Project	<b>IEEE 802.16 Broadband Wireless Access Working Group</b> < <a href="http://ieee802.org/16">http://ieee802.org/16</a> >		
Title	<b>Ad hoc on CMI TX and RX</b>		
Date Submitted	<b>2007-11-12</b>		
Source(s)	Shulan Feng Hisilicon Tech. Co., LTD Bld.17, No.8, Dongbeiwang West Road, Hai-Dian District, Beijing, P. R. China	Voice: Fax: e-mail to :	+86-10-82829151 +86-10-82829075 <a href="mailto:fengsl@hisilicon.com">fengsl@hisilicon.com</a>
Re:	IEEE 802.16 Working Group Letter Ballot #29		
Abstract	Ad hoc on SSURF message transmission.		
Purpose	Discussion and accept.		
Notice	<i>This document does not represent the agreed views of the IEEE 802.16 Working Group or any of its subgroups. It represents only the views of the participants listed in the "Source(s)" field above. It is offered as a basis for discussion. It is not binding on the contributor(s), who reserve(s) the right to add, amend or withdraw material contained herein.</i>

## Ad hoc on CMI TX and RX

Figure 1

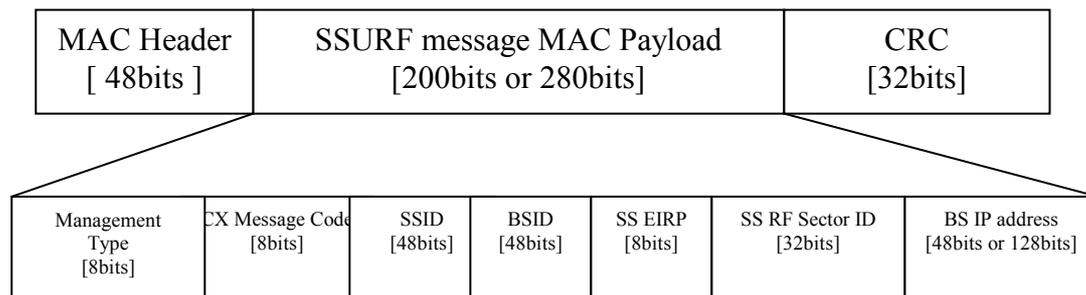
From the following figure, if no location information contained in SSURF message, the number of information

bit from MAC layer to PHY layer is 280bits for IPV4 or 360bits for IPV6.

If SS GPS location information contained in SSURF message, additional 32 bits need to be carrier. So 312 data subcarriers or 392 data subcarriers are needed to carrier SSURF message.

Figure 2

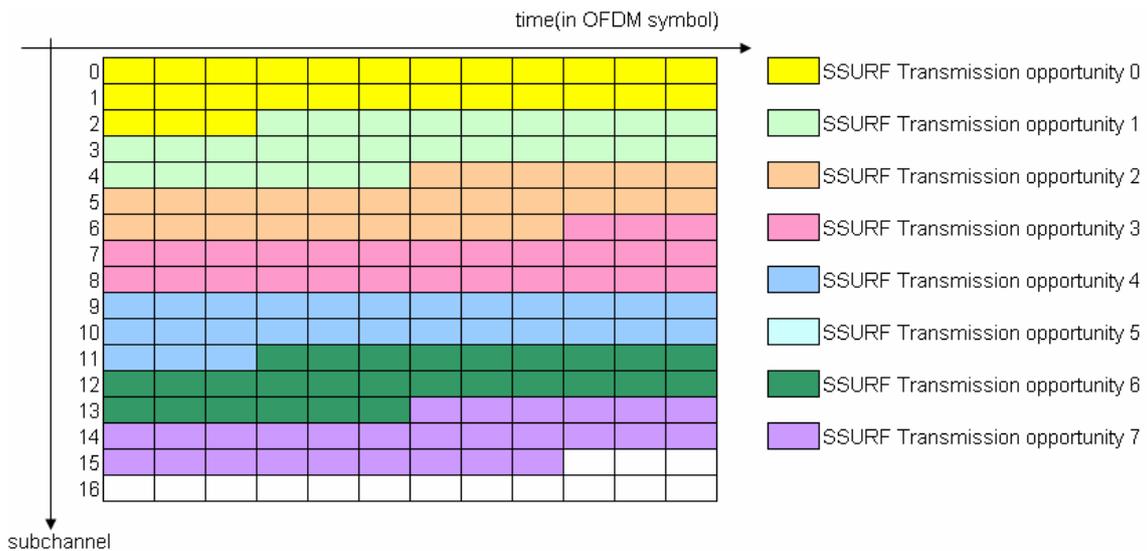
1. Following PHY parameters are used for SSURF message transmission. Channel Bandwidth: 5MHz; FFT Size: 512; CP: 1/8 [ 1/4 is not mandatory in WiMAX mobile profile ]; PUSC: use PUSC in 8.4.6.2.1; Partitioning of subcarriers into subchannel: following the way specified in 8.4.6.2.2 with UL\_PermBase= 0;
2. Defined the length of CMI\_U is 12 OFDM symbols.
3. Every 7 slots for IPV4 or 9 slots for IPV6 are defined as a SSURF transmission opportunity.
4. The first SSURF transmission opportunity in CMI\_U is start at the lowest subchannel and lowest OFDMA slot in the CMI\_U zone. The SSURF transmission opportunity continues mapping with OFDMA symbol index is increased. When the edge of the UL zone is reached, continue the mapping from the lowest numbered OFDMA symbol in the next available subchannel. The figure 2 shows the transmission opportunity allocation for IPV6.

- Following the syntax in table 1 or other way to define a special MAP to tell the SS during which SSURF transmission opportunity it will send SSURF message.

**Figure hxx SSURF transmission opportunity allocation for WirelessMAN-OFDMA**

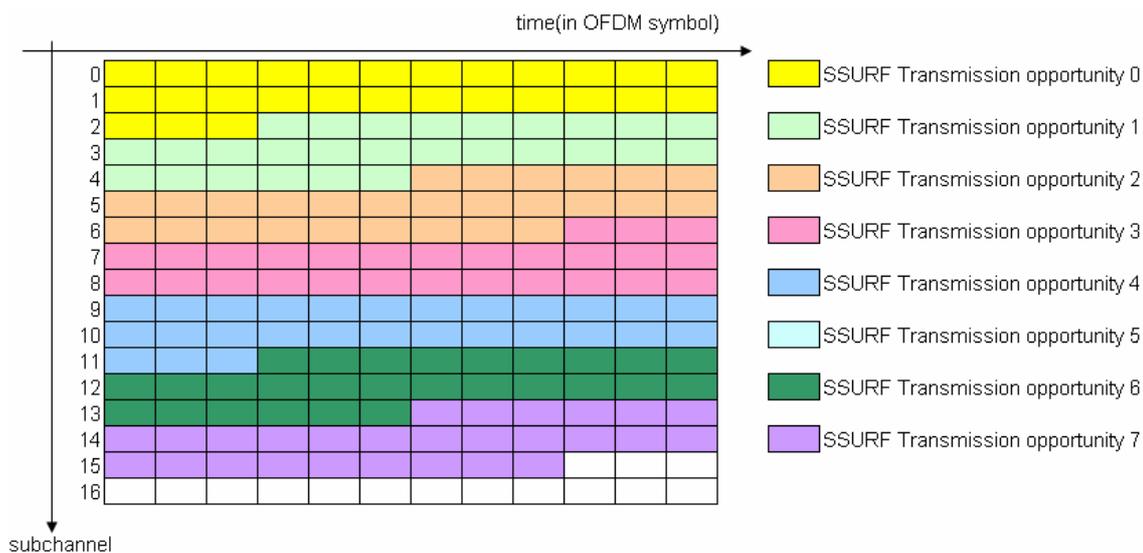
Every 9 slots are defined as a SSURF transmission opportunity. CX\_CMI\_U is the last 12 OFDMA symbols in a 5ms frame and contains 8 SSURF transmission opportunities. The first SSURF transmission opportunity in CX\_CMI\_U is start at the lowest subchannel and lowest OFDMA slot in the CMI\_U zone. The SSURF transmission opportunity continues mapping with OFDMA symbol index is increased. When the edge of the UL zone is reached, continue the mapping from the lowest numbered OFDMA symbol in the next available subchannel. The following figure shows the SSURF transmission opportunity allocation.

SSURF\_transmission\_IE in UL-MAP is used to SS during which SSURF transmission opportunity it will send SSURF message.
